System Impact Assessment Report

Project: Barwick TS

Applicant: Hydro One Networks Inc.

CAA ID 2010-378

FIGURE 1. BARWICK TS SUPPLIED FROM 115 kV CIRCUIT K6F AT AINSWORTH JUNCTION

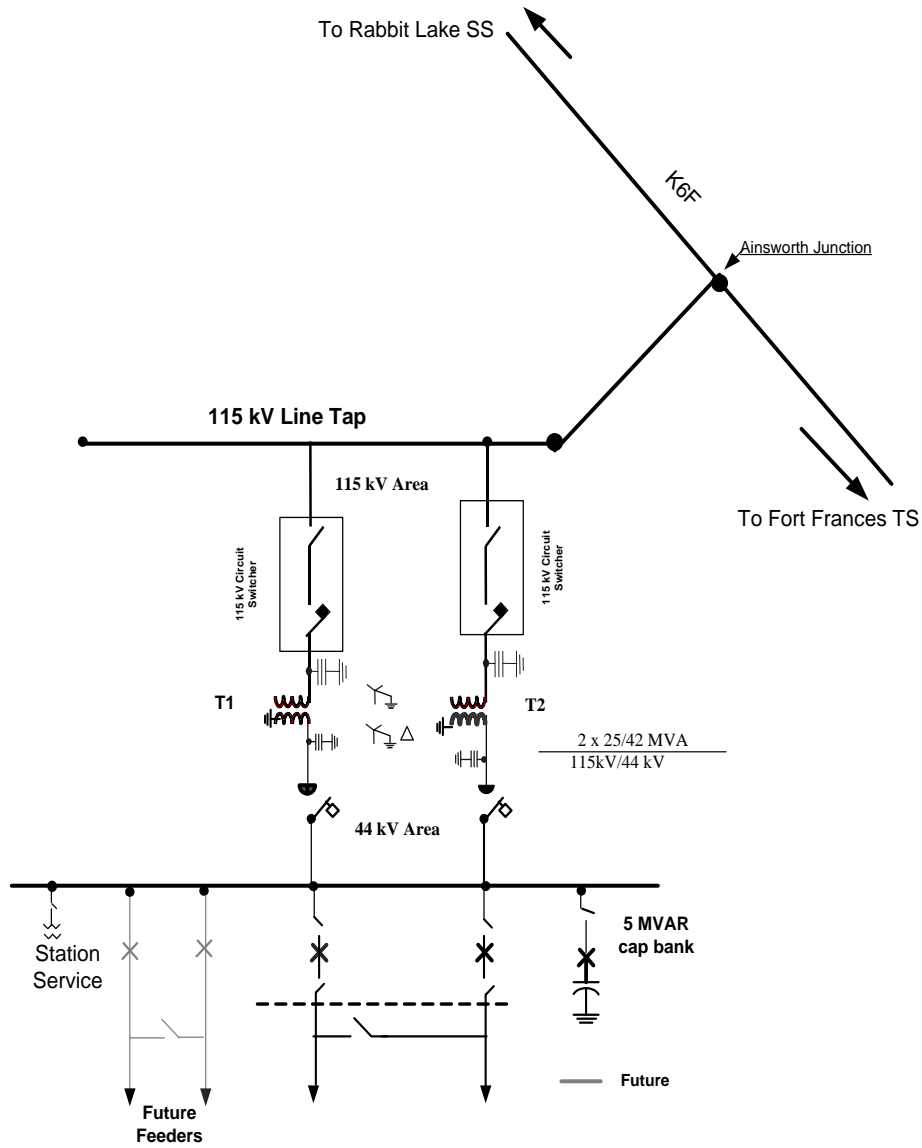
The applicant proposes building a new transformer station that would be supplied via 115 kV line taps from Ainsworth Junction to the existing Ainsworth 4J line tapped from 115 kV circuit K6F.

The transformer station would be equipped with two 115.5 kV - 44kV, 25/42 MVA transformers (ONAN/ONAF). The HV and LV windings would be connected Wye-Wye, and the tertiary winding would be buried. The neutral point of the transformer LV winding would be solidly grounded. The transformers would be equipped with an Under Load Tap Changer (ULTC) with the range of +/- 8.8 kV in 32 steps.

The new transformers would be protected against surges on the HV and LV side by station class surge arresters.

Each of the new transformers would be connected to the 115 kV bus via a 138 kV disconnect switch and SF6 circuit switcher with a rated symmetrical short circuit capability of 20 kA.

The high-voltage switches and connections would be capable of carrying a load of 56 MVA each in both summer and winter. The high-voltage switches and circuit switchers would be capable of operating up to minus 50°C.

Initially two 44 kV feeder positions would be installed, with feeder breakers to isolate the LV side of the transformer during fault conditions. Provision would also be made for two additional feeder breakers for future feeders.

One 5 Mvar capacitor bank and circuit breaker would be installed on the 44 kV side of the transformer, to provide voltage support.

The proposed equipment at Barwick TS satisfies the IESO requirements for connection.

Appendix 2 of the Transmission System Code (TSC) specifies that the maximum 3-phase single line to ground symmetrical fault levels for 115 kV systems is 50 kA. However, the rated symmetrical short circuit capability of the circuit interrupters at Barwick TS is 20 kA, sufficient to accommodate the current short circuit level. If future system enhancements result in increased fault level in excess of the equipment's capability, Hydro One Networks Inc. is required to replace the equipment at its own expense with higher rated equipment capable of sustaining the increased fault level, up to the maximum fault level specified in Appendix 2 of the Transmission System Code.
